Agenda
City of Springboro Planning Commission Meeting
Wednesday, September 10, 2025, 6:00 p.m.
Council Chambers, City Building, 320 West Central Avenue

Background Information & Staff Recommendations
City of Springboro Planning Commission Meeting
Wednesday, September 10, 2025, 6:00 p.m.
Council Chambers, City Building, 320 West Central Avenue

Site Plan Review, 216 Tahlequah Trail, building addition, new parking lot for Thaler Machine

PLOT PLAN
LOT 78 (12,458 SF) 0.2860 AC.
BECK RIDGE, SECTION THREE
CITY OF SPRINGBORO
CLEARCREEK TWP. WARREN COUNTY, OHIO

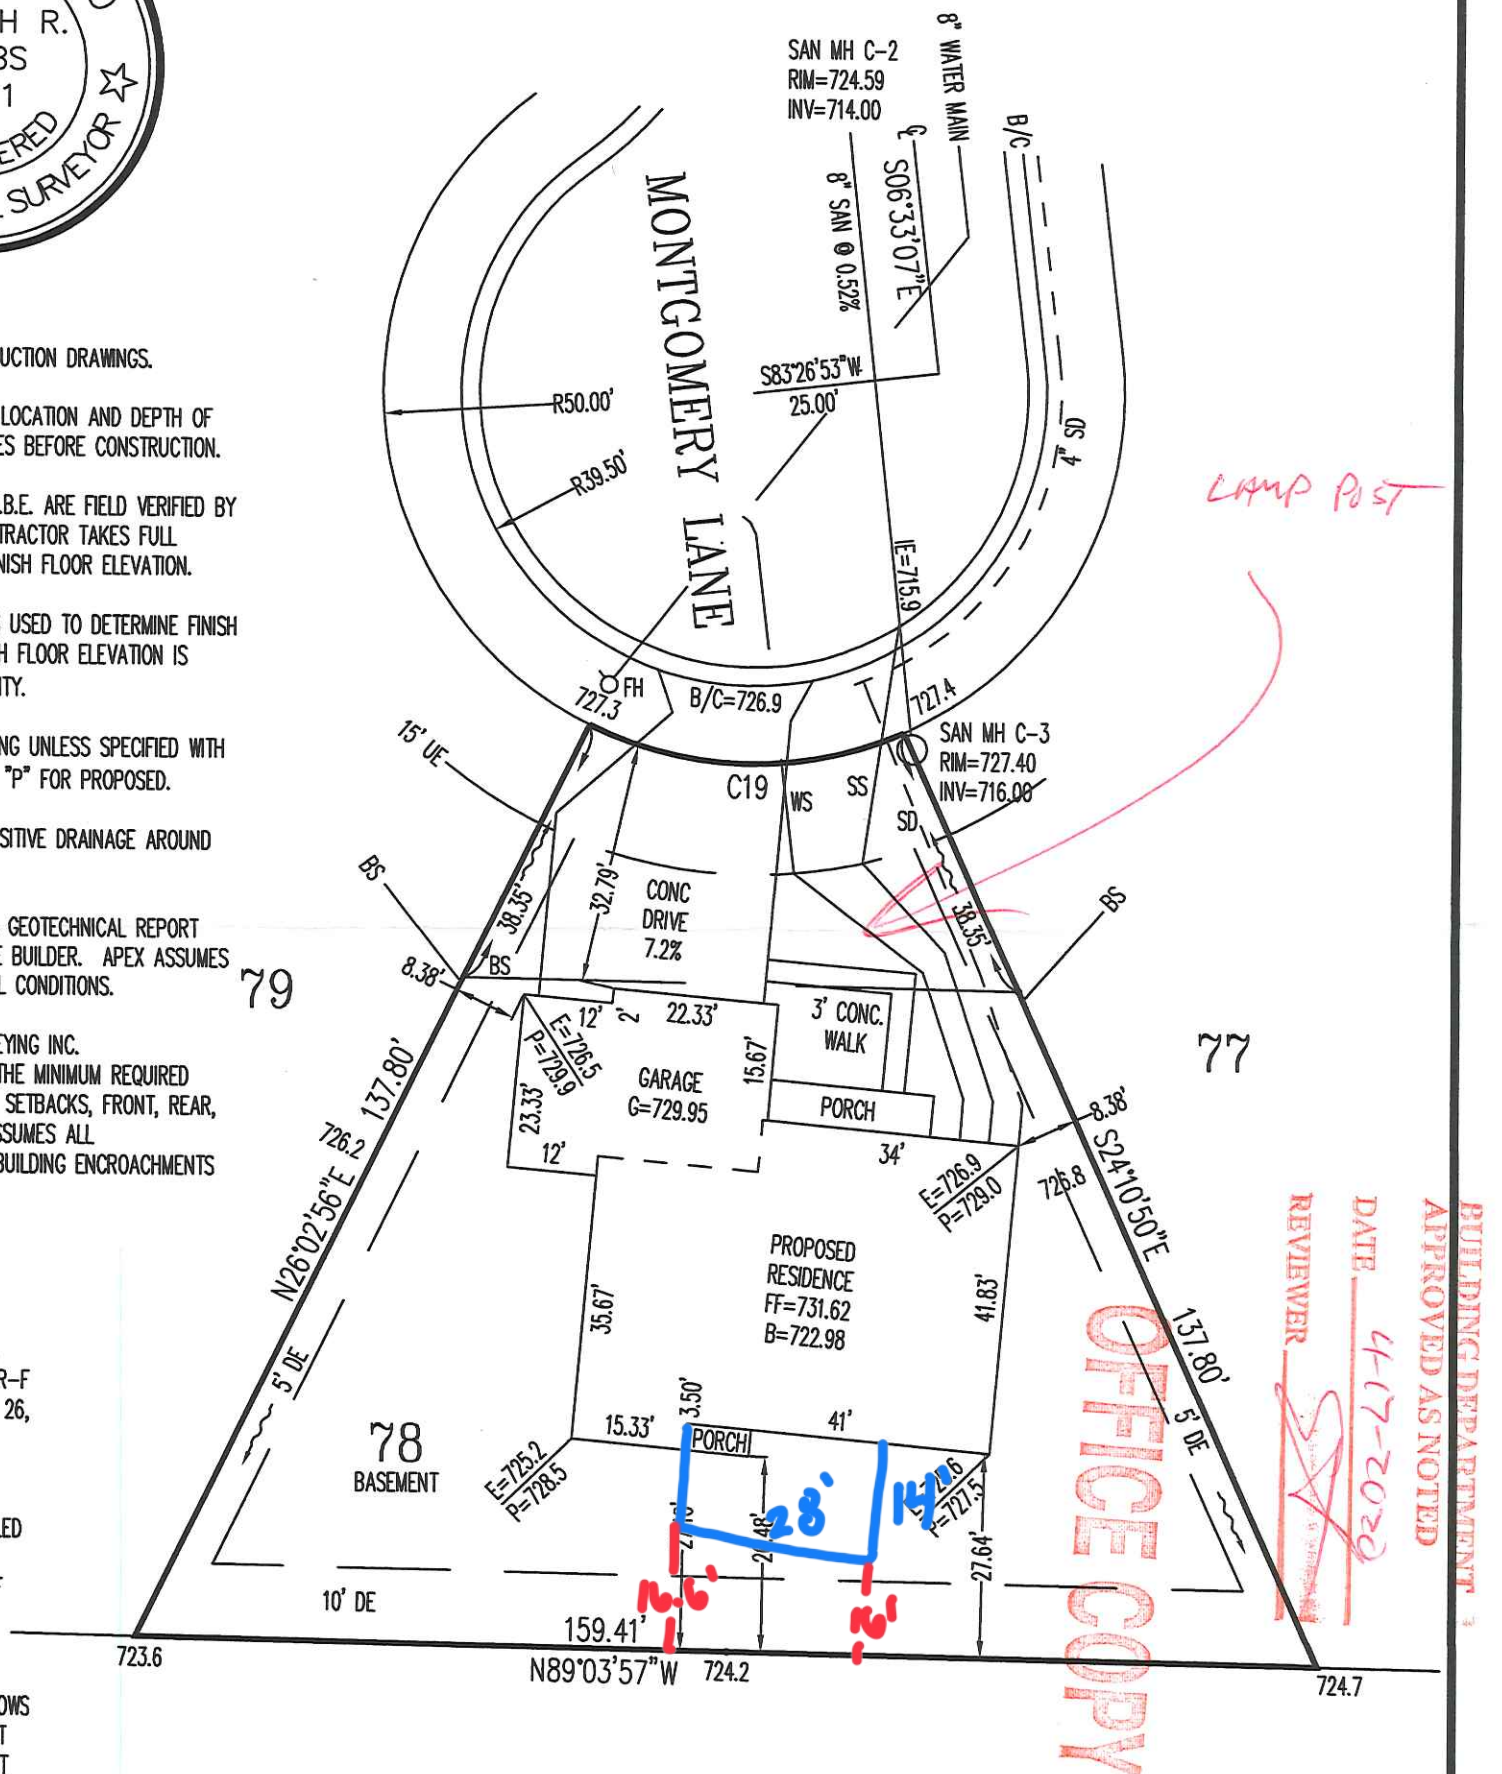
This agenda item is an application, filed by Nathan Carmack, contractor, on behalf of Hannah and Daren Yingling, property owners, requesting a variance from the minimum rear setback to allow the construction of a covered patio on the residence located at 295 Montgomery Lane in the Beck Ridge subdivision. The rear yard setback for this property is 25 feet; the applicants would like to construct an attached covering to an existing patio to within 16 feet of the rear property line.

This item was reviewed on a preliminary basis at the August 20 Planning Commission meeting. The documentation requested by City staff—Beck Ridge homeowners association (HOA) indicating approval of the proposed construction, as well as neighbors owning properties on abutting property—has been submitted.

City staff recommends approval of the variance request as submitted.

C-1.1

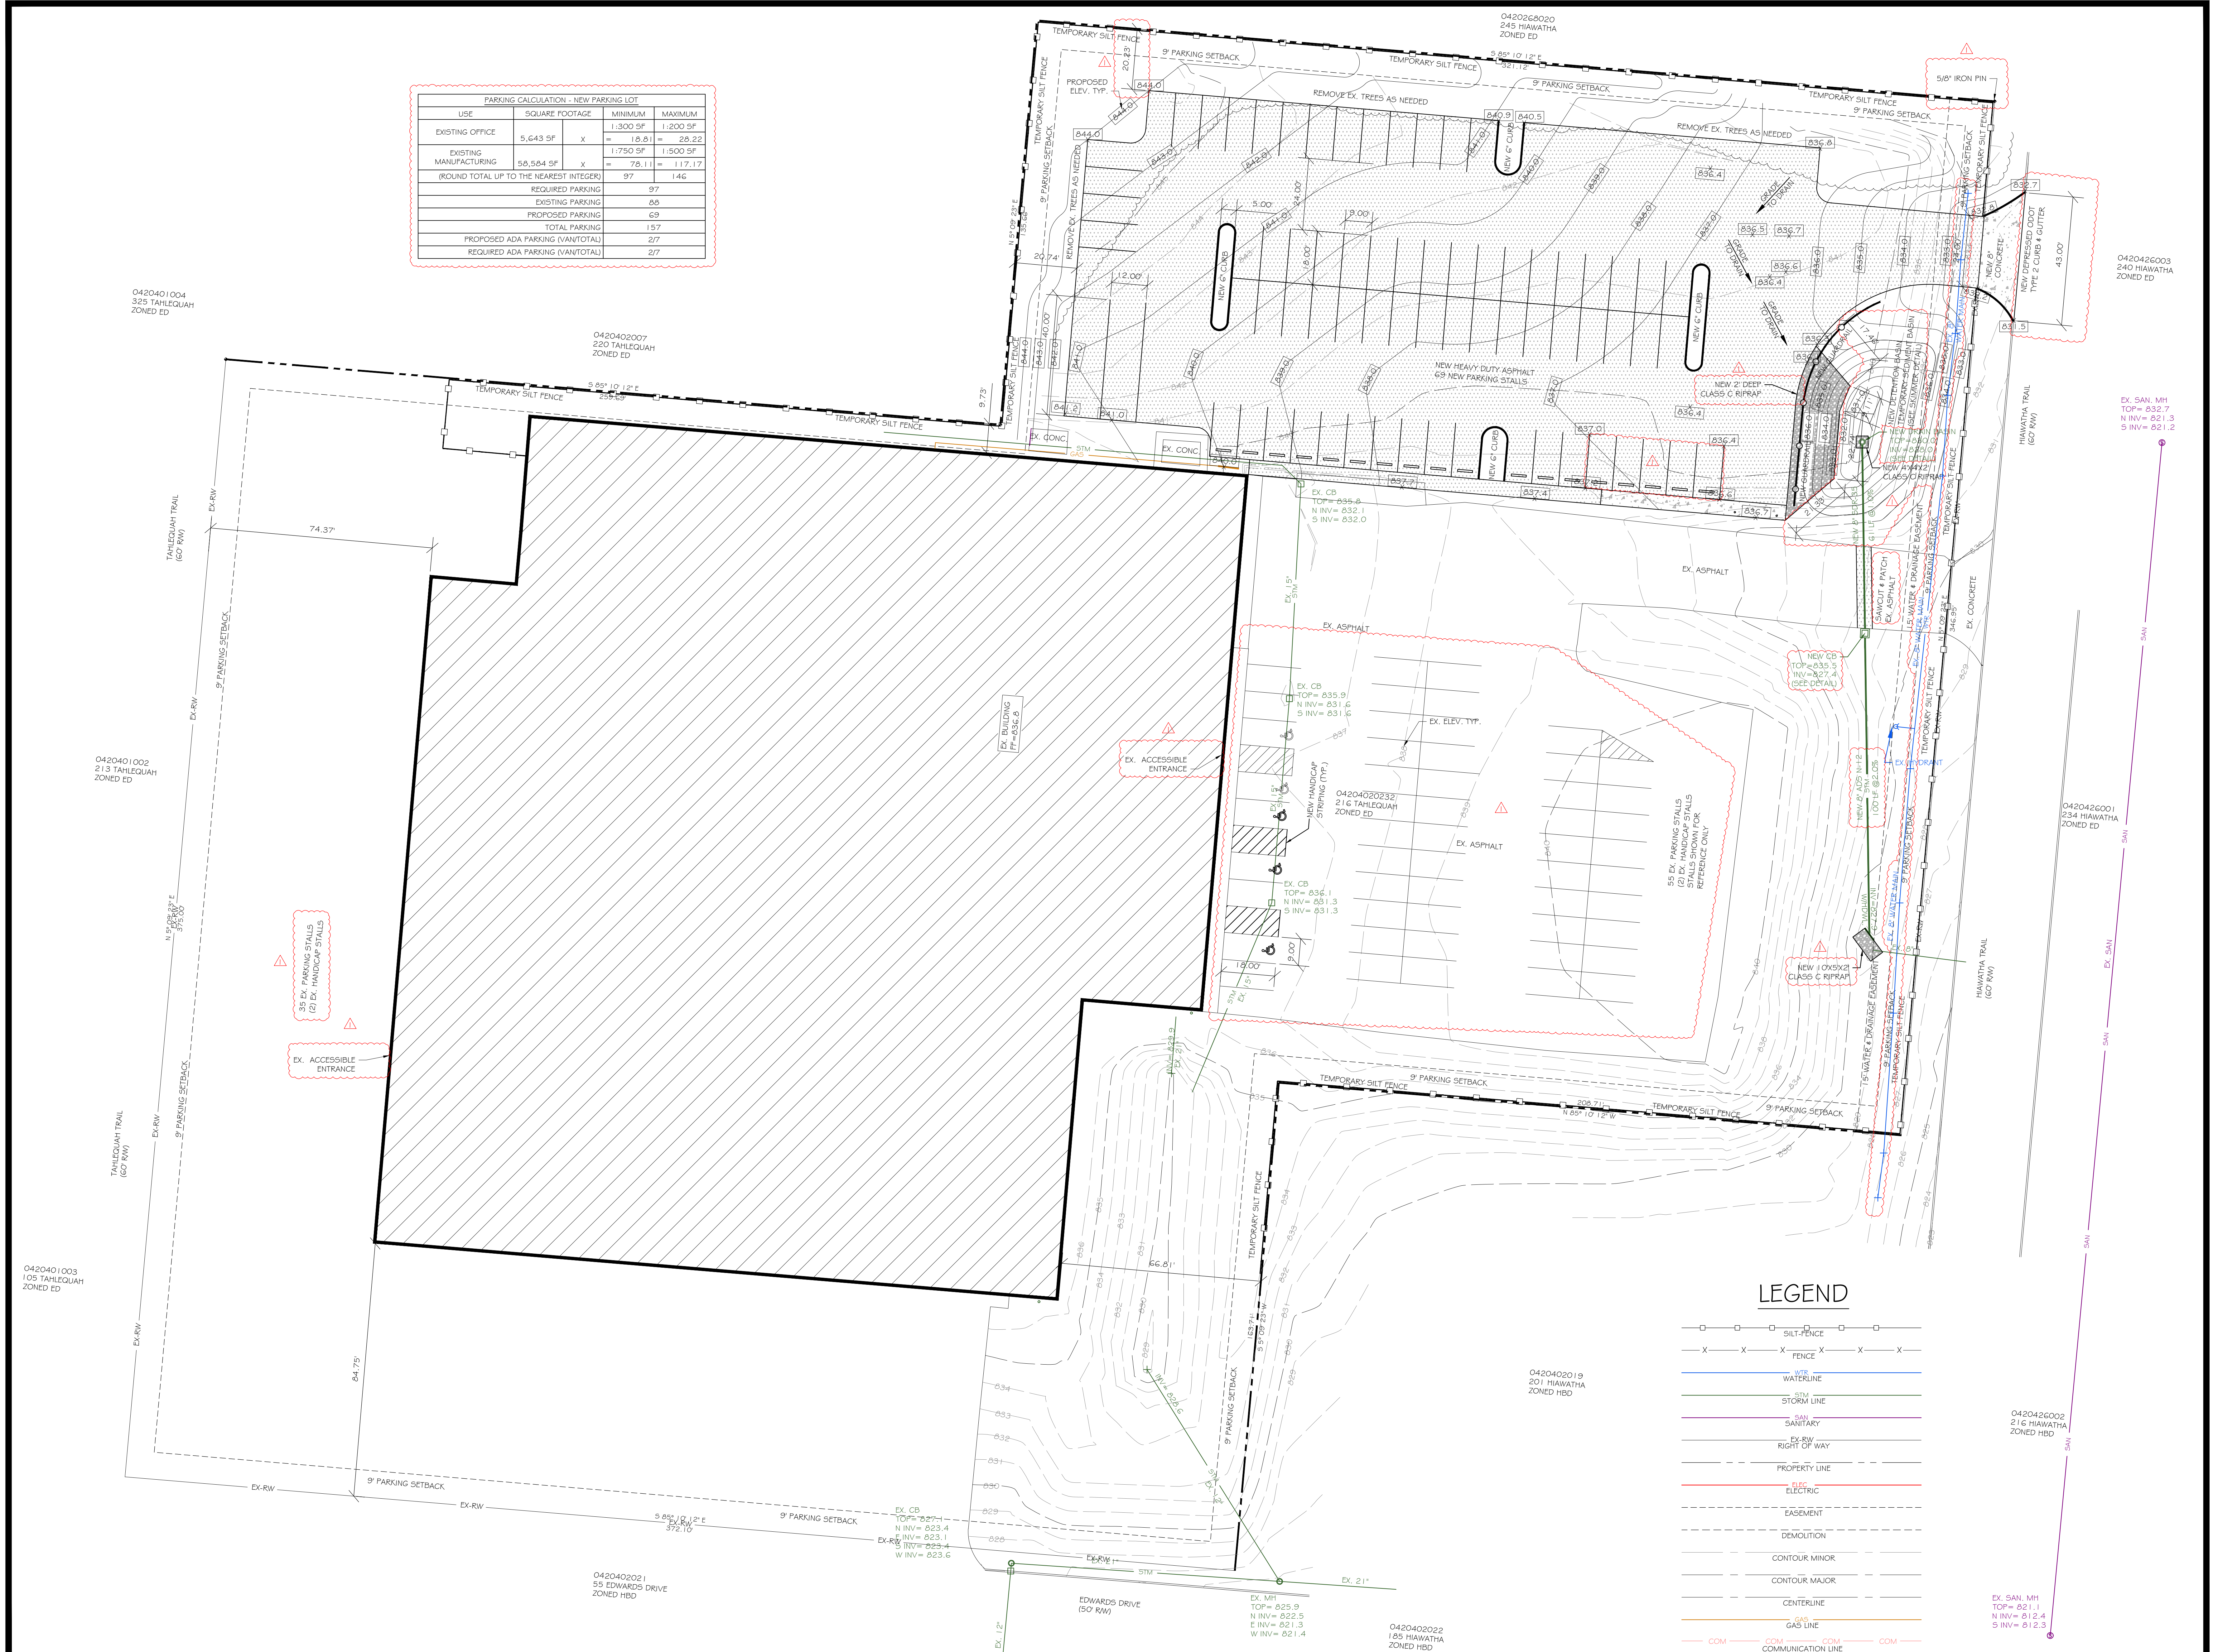
7. Locate existing 8-inch water main and verify min depth of 4.5 feet for improvements. Otherwise, lower watermain accordingly.
8. Add note at curb cut stating that existing curb and gutter to be removed and replaced with depressed ODOT Type 2 curb and gutter.
9. Provide Storm Water Pollution Prevention Plan (SWPPP) per EPA requirements.
10. Identify benchmark.

5. A note to remove existing curb and replace with ODOT Type 2 curb and gutter has been added to sheet C-1.1. The width of the new curb cut is 43' and the width of the new access drive is 24'. See sheet C-1.2.

SITE PLAN
C-1.2

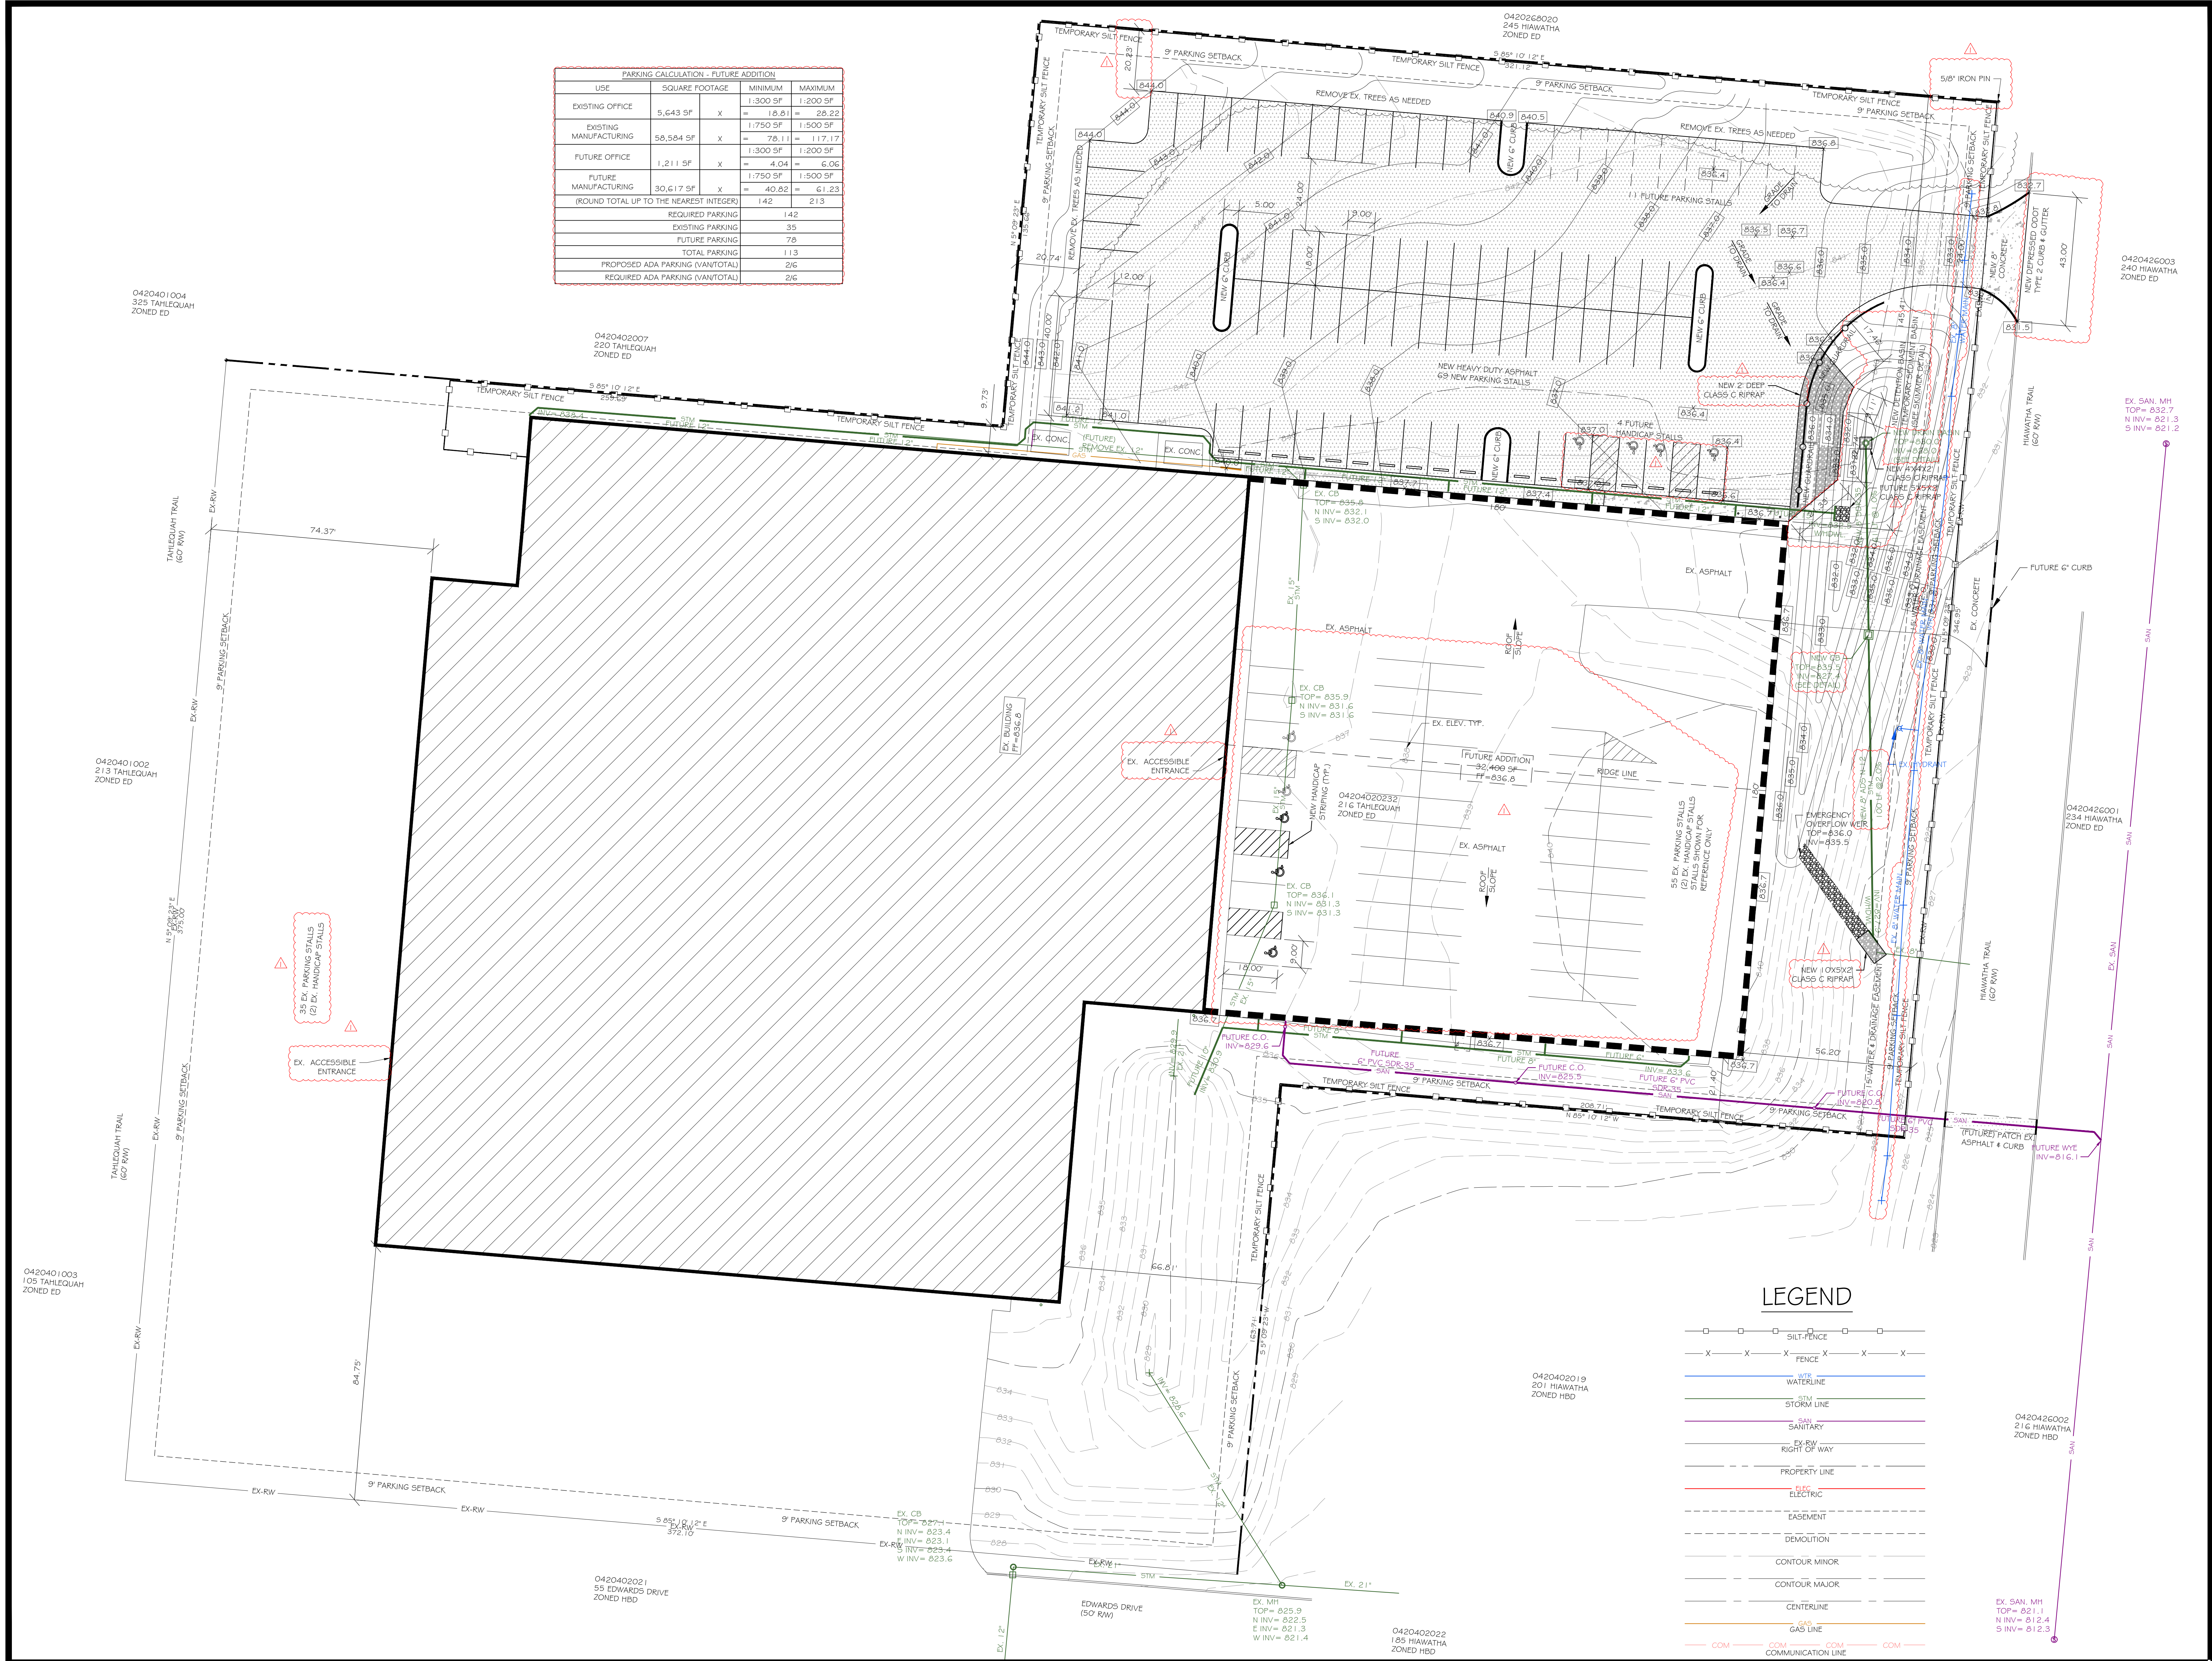
4. Provide proposed building population (at build-out) that is being used to determine parking lot requirements for the site.
5. Provide information on how pedestrian access will be provided between the parking lot and existing/proposed building.

6. Detention design under review.

1. Please see attached storm water report for detention design calculations.
2. The existing 8" water main has been located on the site plan. The existing water main currently has 7' of cover over the new access drive location. After improvements, the water main will have 5' of cover.

3. Storm sewer pipe length, slope, and material have been added to sheet C-1.2. See sheet C-2.1 for storm structure details.
4. Rip-rap width and depth have been added to sheet C-1.2.

6. The parking lot has been tied down to the north property line and a benchmark has been identified, see sheet C-1.2.
7. Rip-rap has been added to the drain basin in the new detention basin to match the detention outlet detail. Please see sheet C-1.2.

8. Asphalt saw cutting and patching has been added to sheet C-1.2 for the new 8" storm crossing. An asphalt patching detail has also been added to sheet C-2.1.

9. Please see sheet C-1.2 for a parking schedule for the current phase of the project and see sheet C-1.3 for a parking schedule for a future phase.
10. ADA access from the parking lot to the building has been added to sheet C-1.2.
